PRODUCT CHANGE NOTICE

**Data Sheet Specification and
Design Change for Intersil
Product ZL9101MIRZ***

**Refer to:
PCN11118**

Date: November 16, 2011

The data sheet electrical table limits and range changes are as follows:

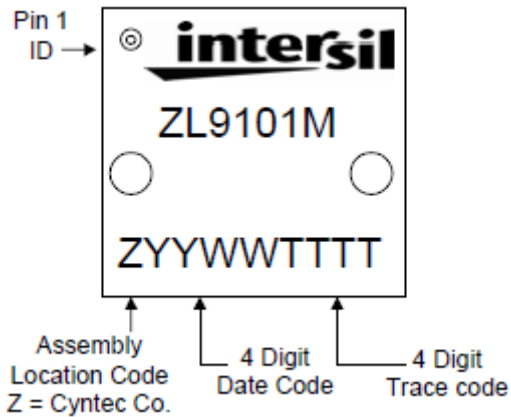
Recommended Operation Conditions	Current Range	New Range
Output Voltage Range, V_{OUT}	0.54V to 4V	0.54V to 3.6V
Output Current Range, I_{OUT}	0A to 15A	0A to 12A

Electrical Specifications - Parameter	Current Limit			New Limit			Unit
	Min	Typ	Max	Min	Typ	Max	
Input Bias Shutdown Current, I_{DDS}	-	9.5	12	-	15.5	20	mA
Input Supply Current, I_{VIN}	-	1.5	2	-	1.32	-	A
Driver Supply Current	-	190	220	-	190	250	uA
Output Load Current	Parameter Added			-	12	-	A
Switching Frequency Range	590	615	630	500	571	1000	kHz

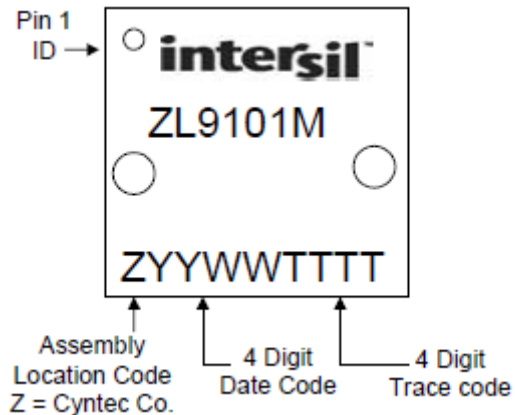
There will be no change in the part number marked on the packaged parts. Product manufactured with the improved design will begin with date code **1131** and use the new Intersil logo. Examples of the current and new branding/marketing layouts are included below.

Current

New
